HUMBOLDT COUNTY DEPARTMENT OF PUBLIC WORKS

Sheet 1 of 2**CONTRACT CHANGE ORDER**Change Requested by: Engineer  Contractor

CCO No. 1	Suppl. No. 0	Contract No. 217101	Road Various Locations	Federal Number(s) HSIPL-5904(161)
--------------	-----------------	------------------------	---------------------------	--------------------------------------

At Project Site 23 - Redwood Drive PM 1.26 to 1.61.

**Figure 11: Guardrail Concrete Beam on Narrow Embankments**

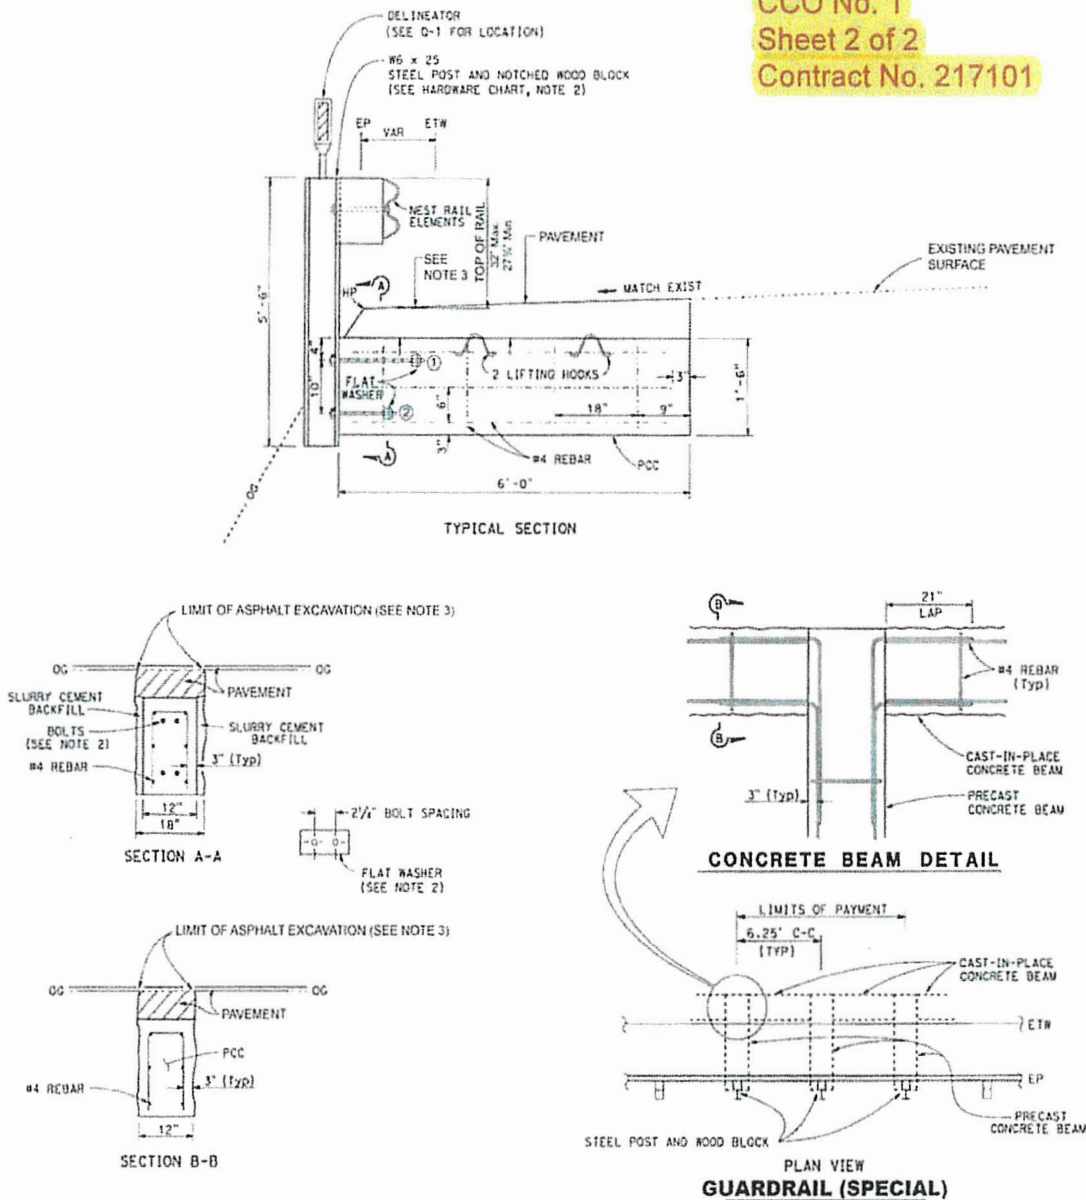
In accordance with the provisions of Section 4-1.05, Changes and Extra Work, of the Standard Specifications, construct an MGS post anchor system depicted on Sheet 2 for a group of seven (7) posts designated by the Engineer.

Special ~~AB~~MGS @ Loc 23
